Lake Oroville Spillways Emergency Recovery

Board of Consultants Memorandum No. 11 – August 25, 2017

SUBJECT: Memorandum No. 11

Figure 2. Photographs of Physical Model of FCO Spillway at Utah State University's Water Research Laboratory

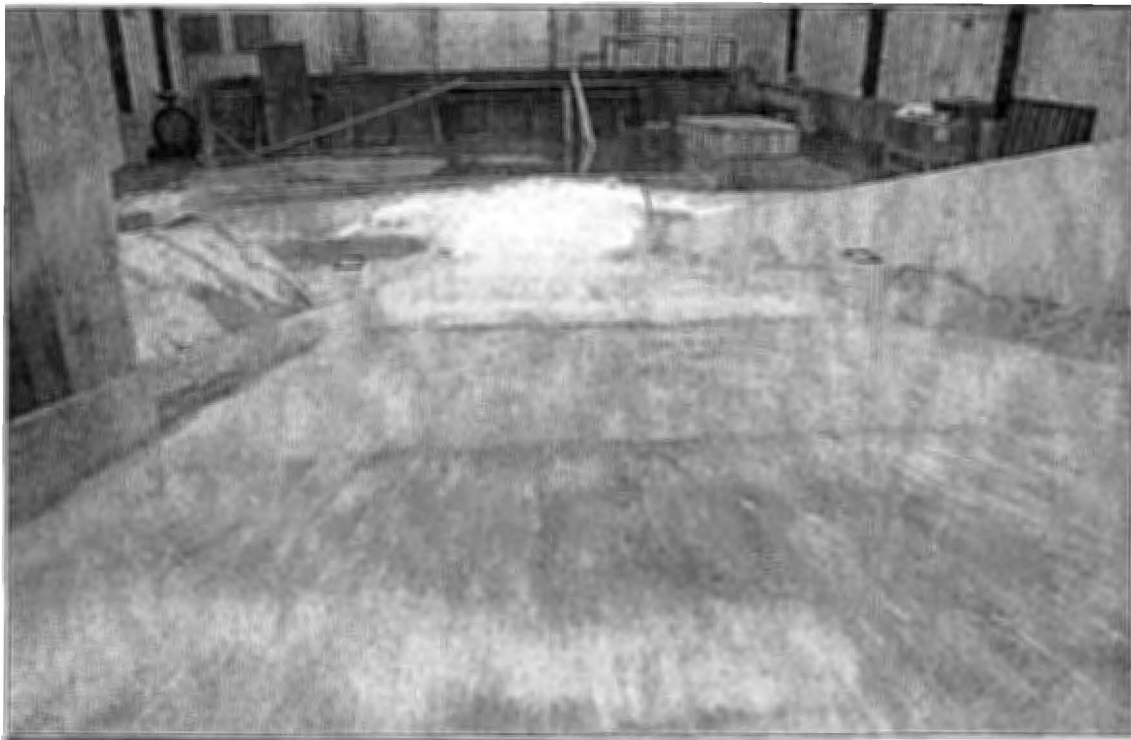
2. On July 31, 2017, Paul Schweiger, on behalf of the BOC, visited the Utah State University's Water Research Laboratory to observe the operation of the physical model of the FCO Spillway. The model study is being conducted under the direction of Dr. Michael Johnson. During the visit, Dr. Johnson and his assistants operated the model for full-scale flows representing 10,000, 20,000, 50,000, 100,000, 150,000 and 270,000 cfs. The version of the model observed included an aerated 30-inch vertical step at Sta. [REDACTED], and two air slots further downstream of the chute [REDACTED]. Observations from the physical model corroborate the numerical computations and design recommendations of the Design Team. The following main observations were made:

a. The two aerators downstream of Sta. [REDACTED] appear to be excessively large and create considerable flow disturbance within the FCO Spillway chute, especially at lower flows. The benefit provided by these additional aerators is questionable.

b. When the 30-inch step at Sta. [REDACTED] is aerated [REDACTED] it appears to perform very well as an aerator for the full range of flows up to the maximum design flow. At the maximum design flow, the amount of air supplied to the step could be increased to improve the aeration for this extreme flow condition, however it still appears to work satisfactorily as an aerator. Increasing the size of the air vents as currently proposed by the Design Team is recommended.
